STATE OF HAWAII DEPARTMENT OF TRANSPORTATION HIGHWAYS DIVISION MECHANICALLY STABILIZED EARTH RETAINING WALL (MSERW) TYPICAL SECTION AND DETAILS KAHKILI HIGHWAY WIDENING Likelike Hwy. to Vicinity of Haiku Road F.A. PROJECT NO. NH-083-1(26) SCALE: AS NOTED DATE: APRIL 1994 SHEET No. W1 OF W21 SHEETS	
--	--

AS-BUILT ADD. 114

KAHEKILI HIGHWAY WIDENING
Likelike Hwy. to Vicinity of Haiku Road
F.A. PROJECT NO. NH-083-1(26)

R C RETAINING WALL SECTION

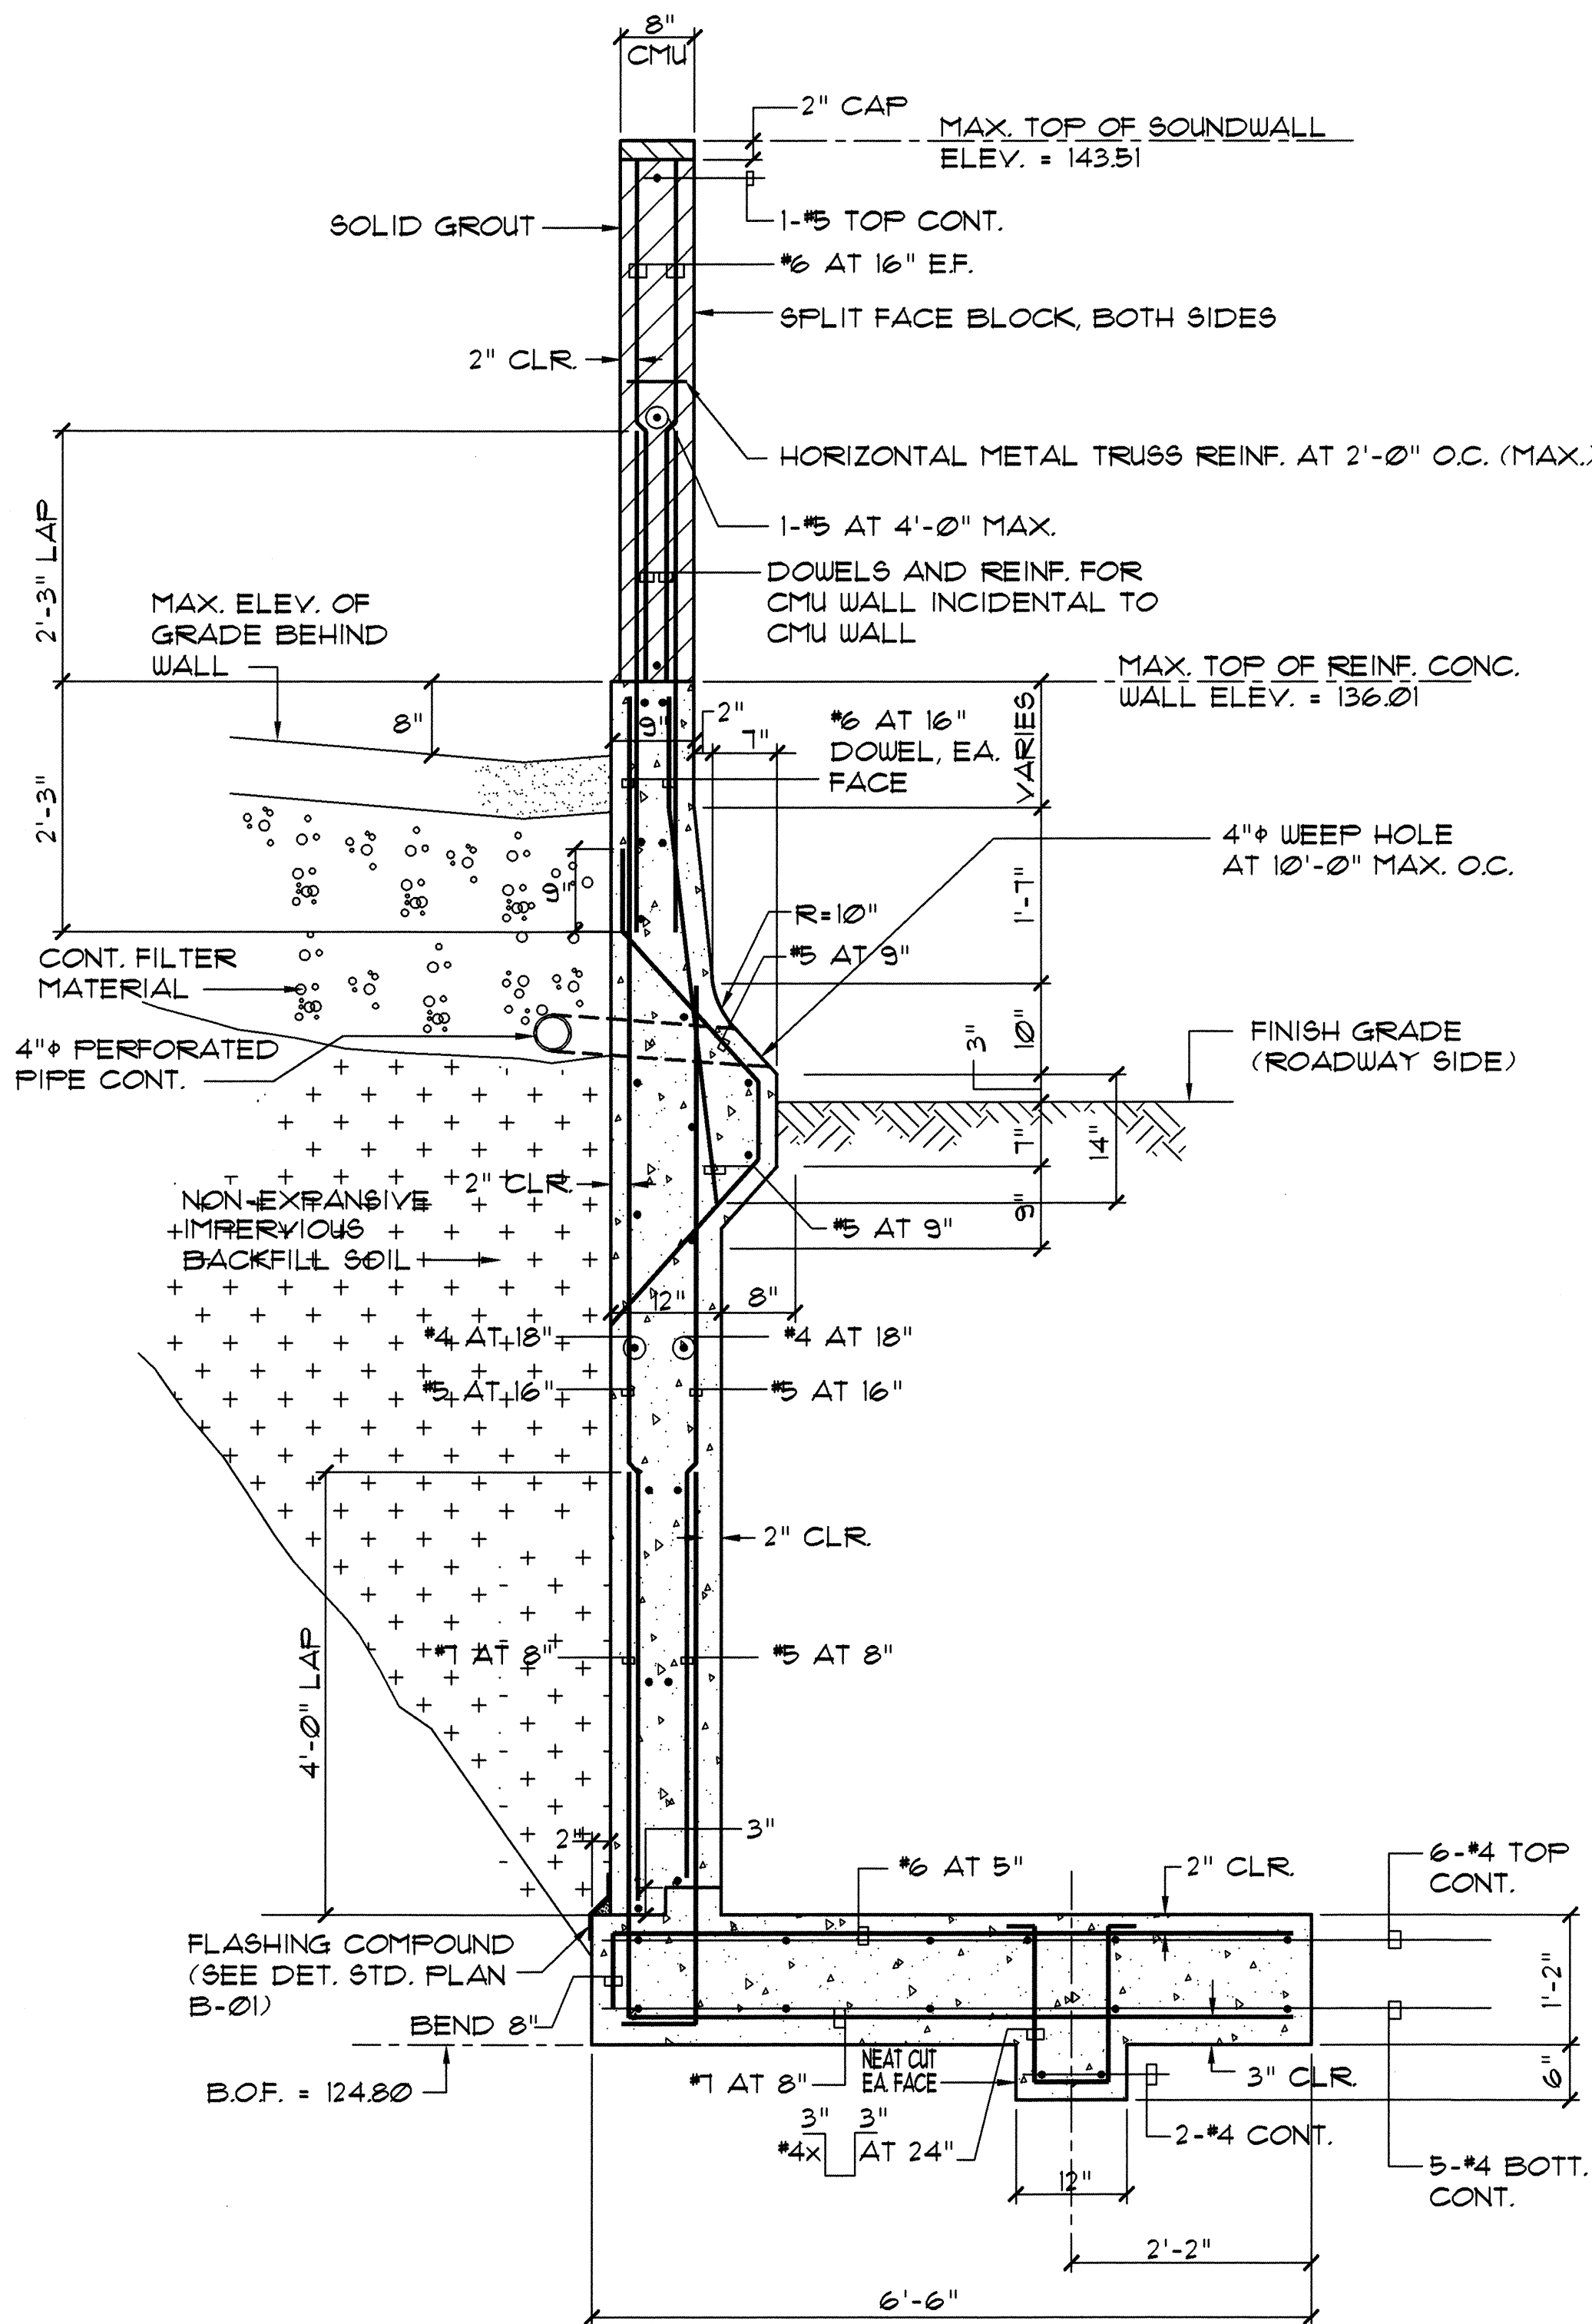
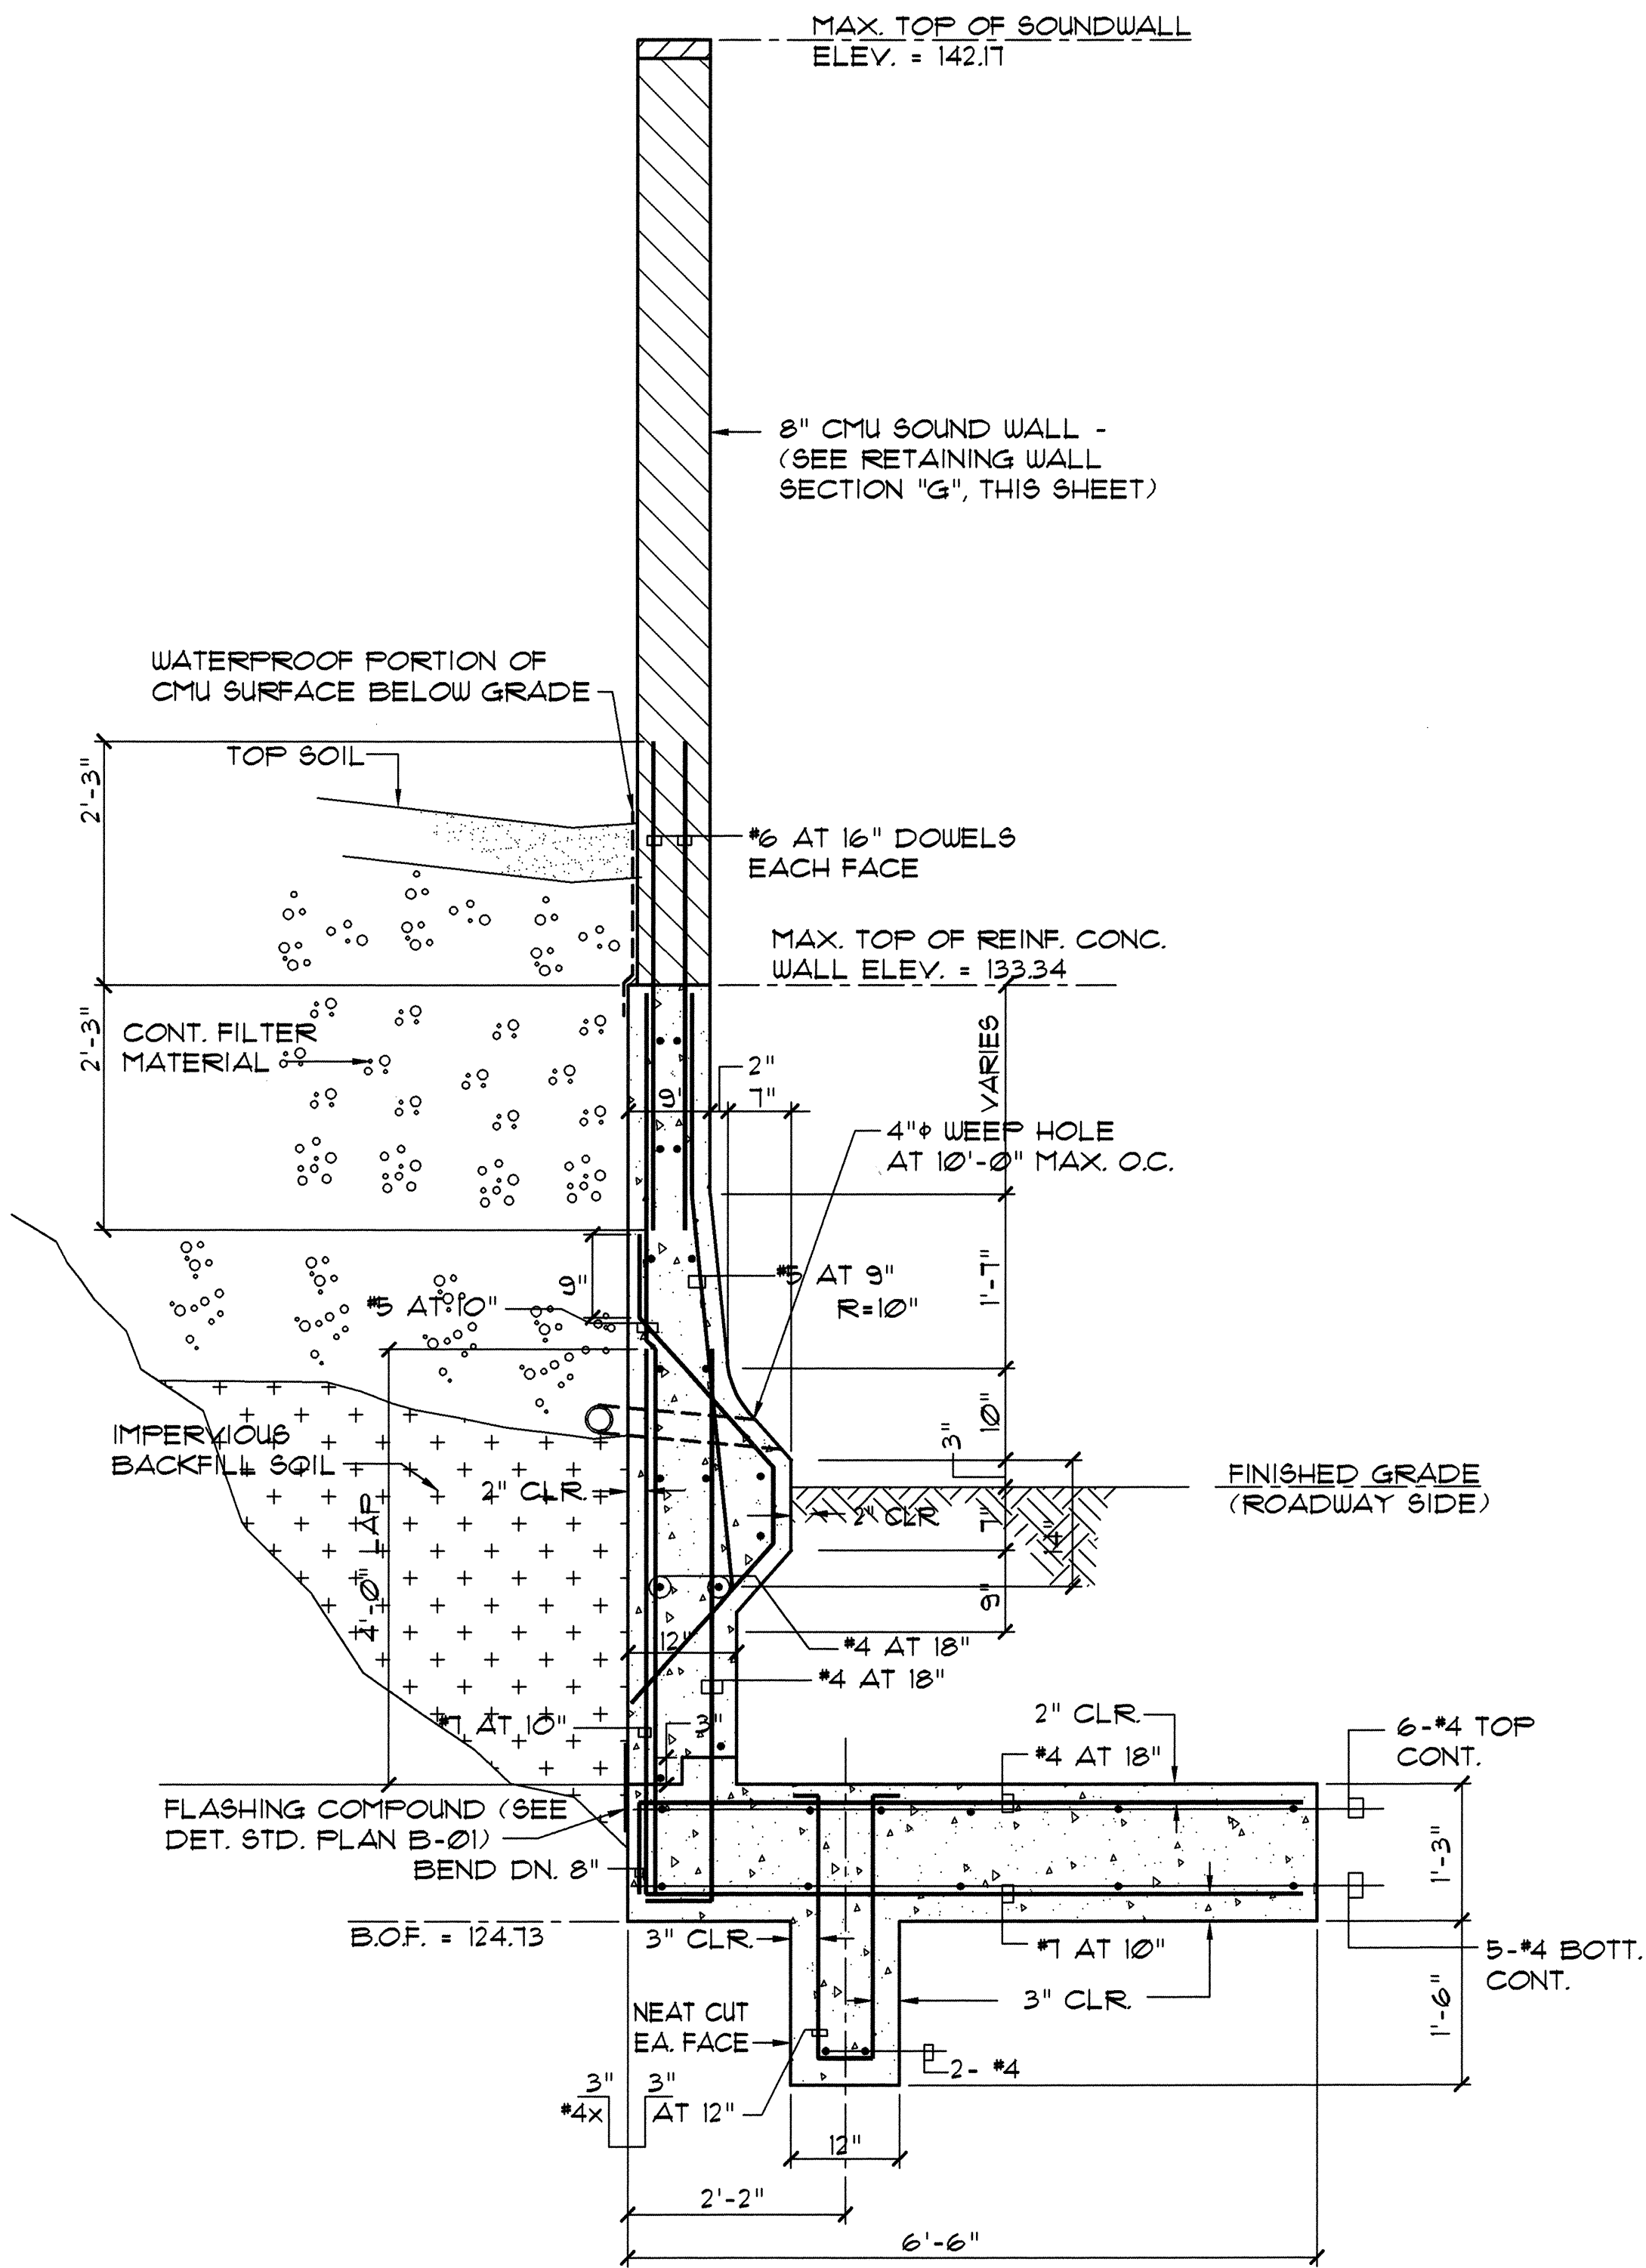
02/02/96	ADDED RETAINING WALL SECTIONS "G" AND "H"
DATE	REVISION

PLAN AND PROFILE
MSERW NO. 1 AND R.C. WALL NO. 1A

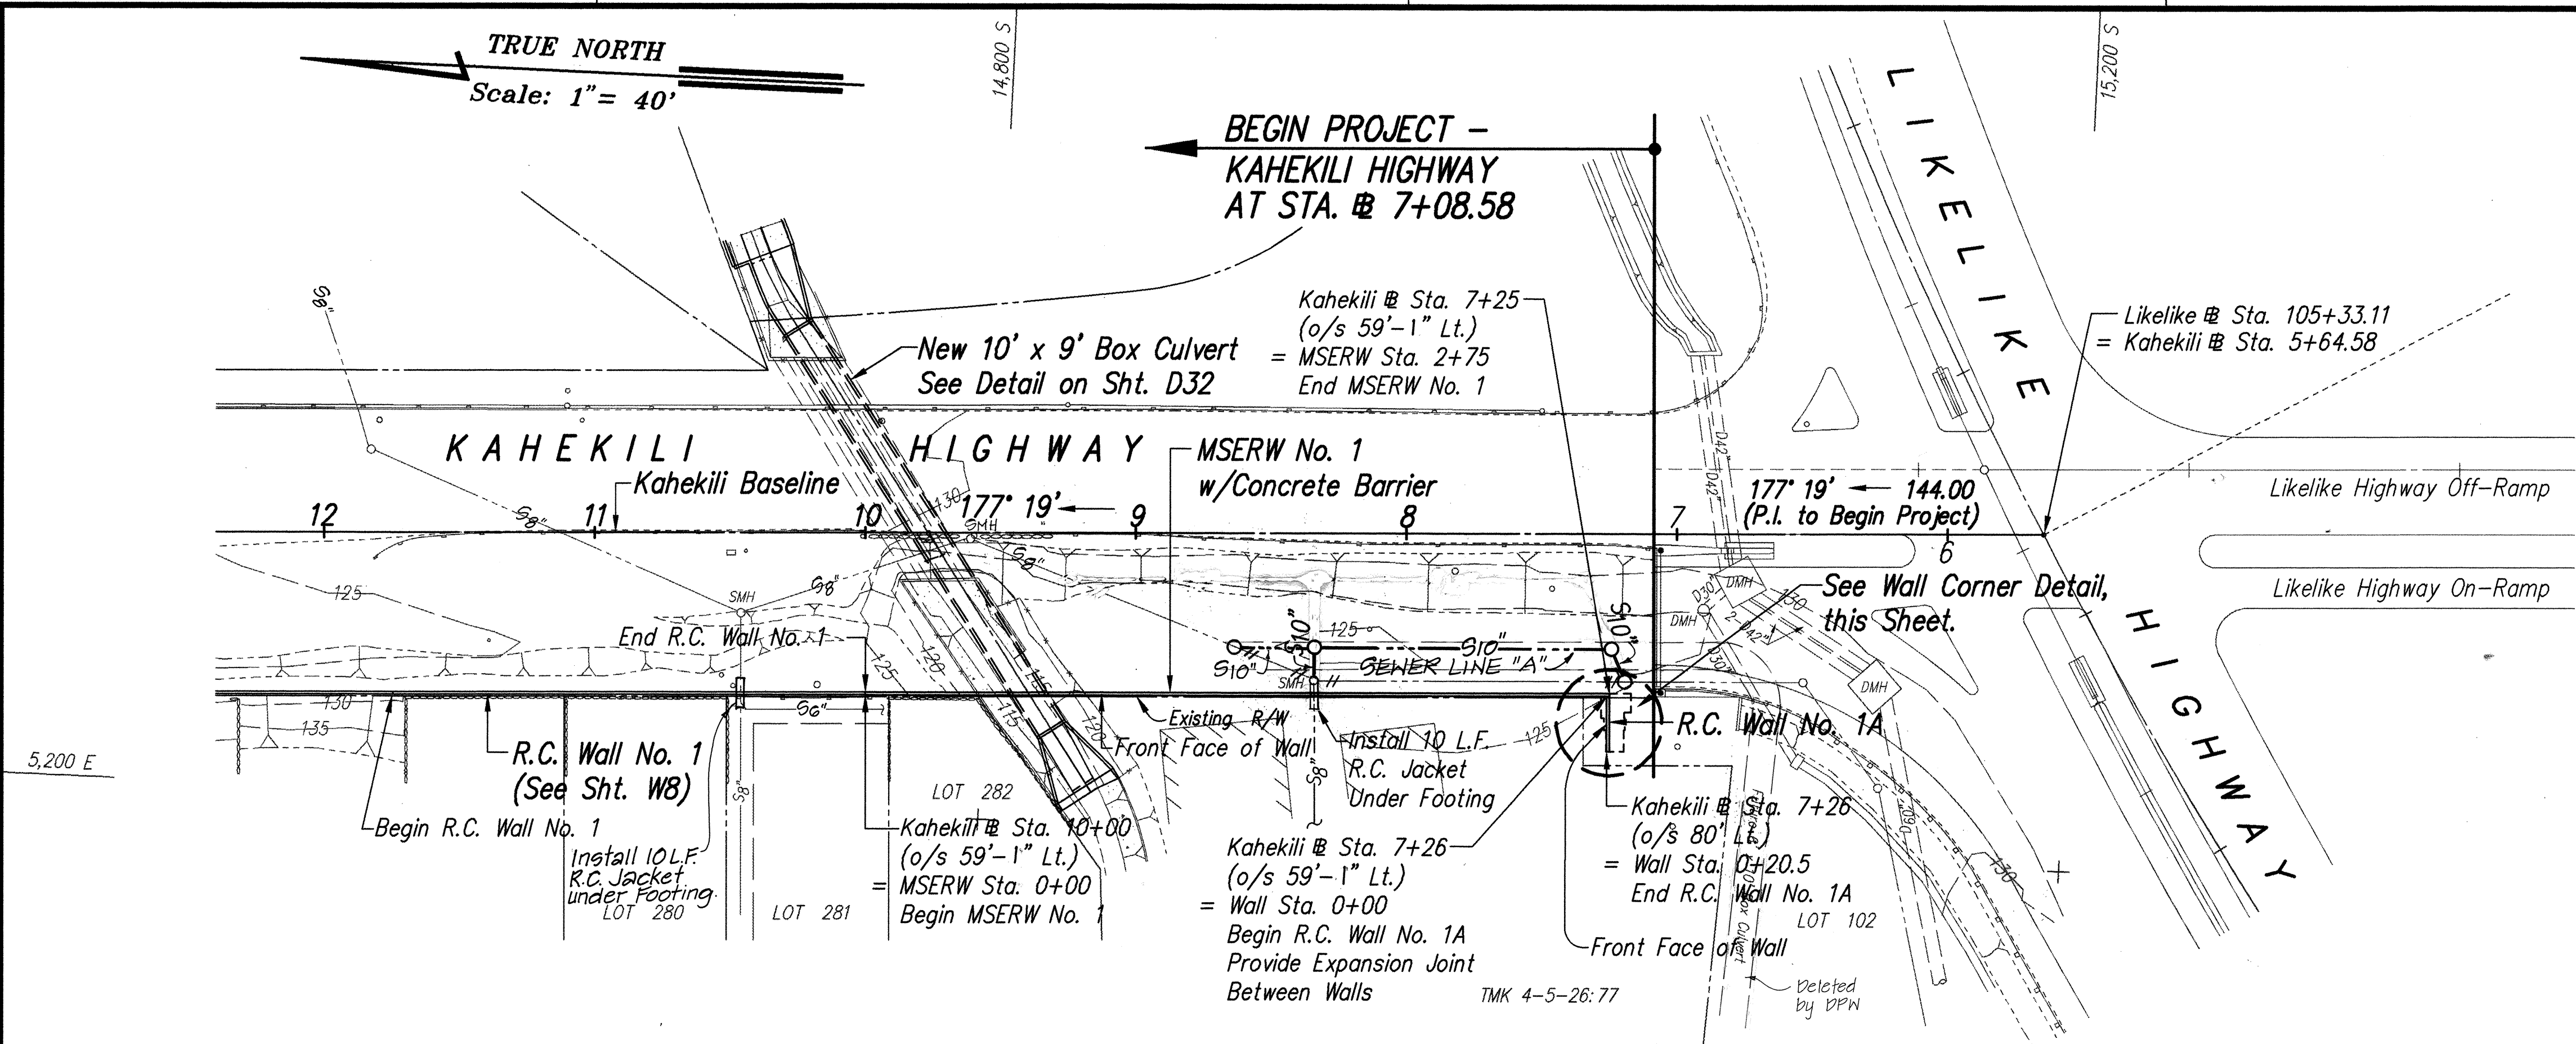
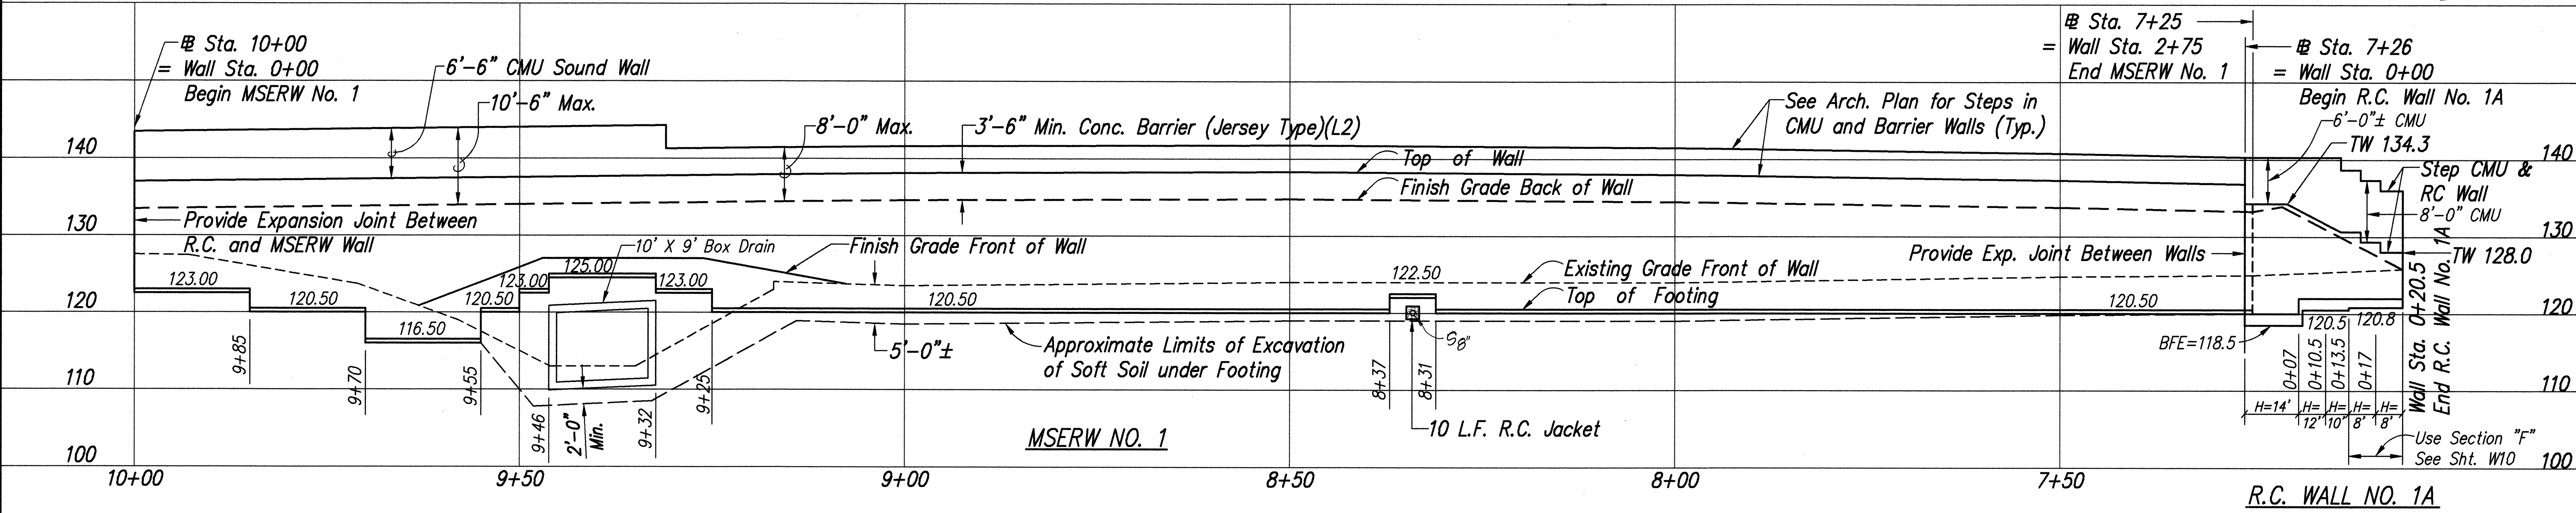
1/11/96	REVISED OFFSETS FOR MSERW NO. 1 AND R.C. WALL NO. 1A
8/3/95	REVISED SEWER LINE "A", PLAN AND PROFILE (DPN DELETED FUTURE 6' X 10' BOX CULVERT)
6/07/94	ADDED DPHM SIGNATURE BLOCK AND SEWER NOTES
6/07/94	REVISED WALL PROFILES AND FOOTINGS.
DATE	REVISION
